NL-14-029

**SUBJECT:** Indian Point Energy Center's Second Six-Month Status Report for the Implementation of Order EA-12-051 Modifying Licenses with Regard to Requirements for to Reliable Spent Fuel Pool Instrumentation (TAC Nos. MF0737 and MF0738)  
Indian Point Unit Numbers 2 and 3  
Docket Nos. 50-247 and 50-286  
License Nos. DPR-26 and DPR-64

ENTERGY'S SECOND SIX-MONTH STATUS REPORT FOR THE  
IMPLEMENTATION OF ORDER EA-12-051 MODIFYING LICENSES  
WITH REGARD TO REQUIREMENTS FOR TO RELIABLE SPENT  
FUEL POOL INSTRUMENTATION

ENTERGY NUCLEAR OPERATIONS, INC.  
INDIAN POINT NUCLEAR GENERATING UNIT NOS. 2 and 3  
DOCKET NOS. 50-247 and 50-286

Figure 1: IP3 SFPI Fan House Cable Routing

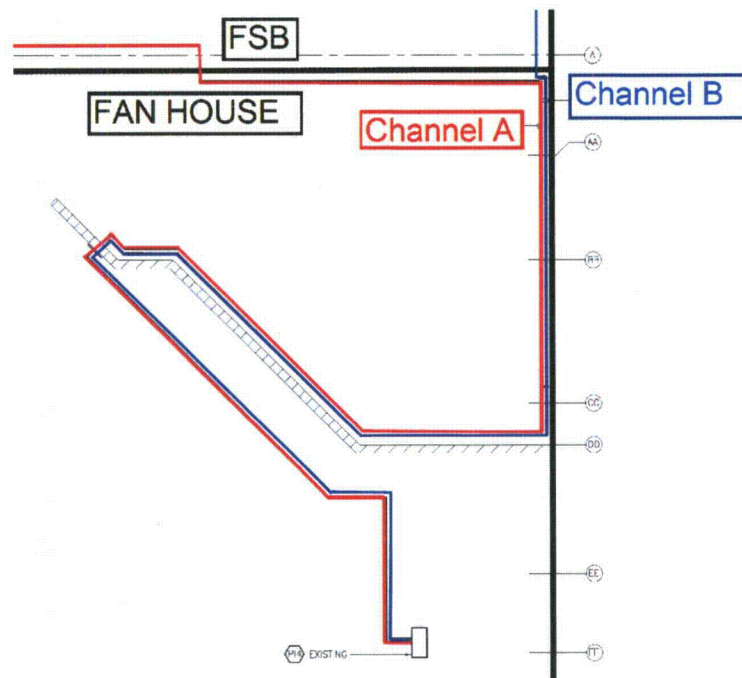
**Please provide a description of the protection provided for the cabling routed along the exterior of the fuel building for Channel B of IP2 and IP3. Also, please provide a sketch to illustrate the remaining cable routing from the fuel building wall penetrations to the processor units for Channel A and Channel B for IP2 and IP3.**

As noted in Sections 4 and 7, the probe locations shown in Attachments 1 and 3 of the OIP have been changed. The Channel A probe is shown where the Channel B probe is located, and the Channel B probe is shown where the Channel A probe is located.

For IP3, Channel A will penetrate through the west wall into the Fan House approximately 30 ft north of the doorway into the Fan House. The Fan House is a Seismic Class 1 structure that is protected against adverse weather conditions. The Channel B route will follow the east wall to the south wall, follow along the south wall and penetrate on the south side of the doorway between the Fan House and the Fuel Storage Building (FSB). Once outside the FSB, the two conduit runs will converge near the door between the FSB and the Fan House. Each channel will maintain plant design channelization requirements by remaining in their dedicated conduits. The two channels will be run down to the 67'-6" Elevation of the PAB Fan House. Both conduits are to be routed through the existing penetration south of the door between the Fan House and the upper mezzanine of the pipe penetration area. Once through the penetration they will be routed down the hall to the Gas Analyzer Rack, which is part of the retired in place Hydrogen Recombiner Panel. The two indicators will be mounted on the panel by removing the retired in place equipment and installing the level indicators. The IP3 SFPI cable routing within the Fan House is shown graphically in Figure 1.
